| REQUEST FOR INFORMATION NOT ADDRESSED IN THIS CCO REMAIN IN FORCE | | | | | |
|---|---|---|---|---|---|
| △1 | 03/04/08 | BARRIER MODIFICATIONS | JS BM | RG SE | 44 |

CONTRACT CHANGE ORDER NO. _____
SHEET _____ OF _____

# DETAILS
## SAS SUPERSTRUCTURE ROADWAY WESTBOUND PANEL UP-108 SCHEDULE
NO SCALE

E-63

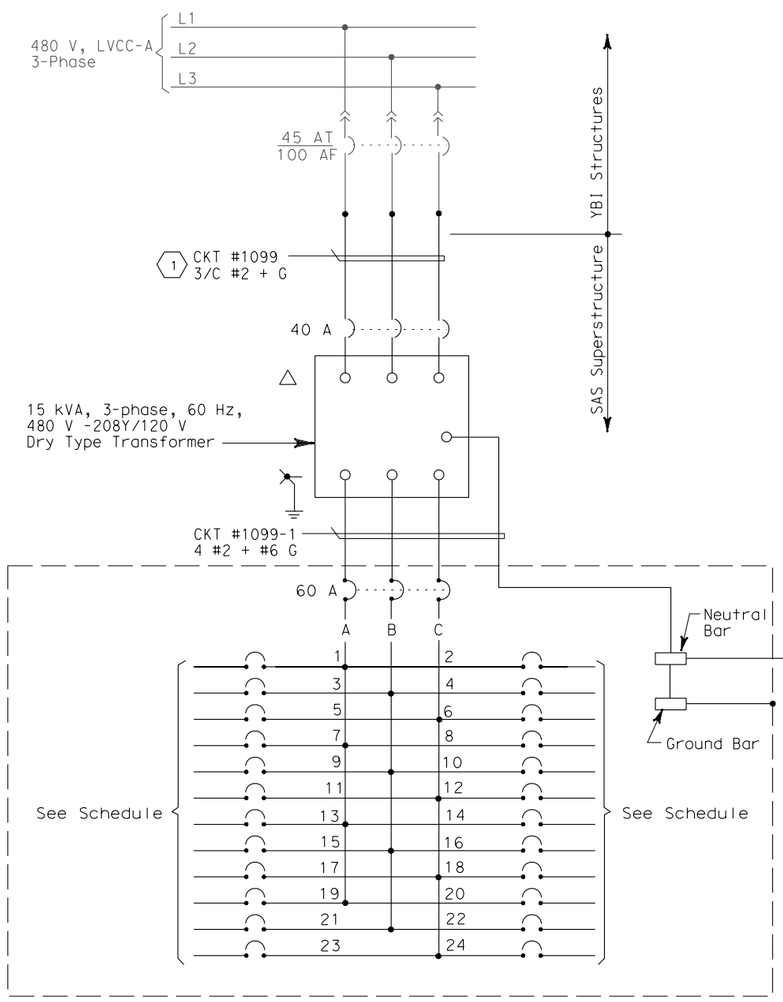
| LOAD DESCRIPTION | LTG | REC | OTH. | CB | | CB | LTG | REC | OTH. | LOAD DESCRIPTION |
|---|---|---|---|---|---|---|---|---|---|---|
| Recept (3) Westbound South Barrier | | 540 | | 20/1 | 3 B 4 | 20/1 | | | 10 △1 | CB-143B 1 |

TOTAL kVA: 5.977 △1

Phase A - 1.884 △1
Phase B - 2.358
Phase C - 1.715
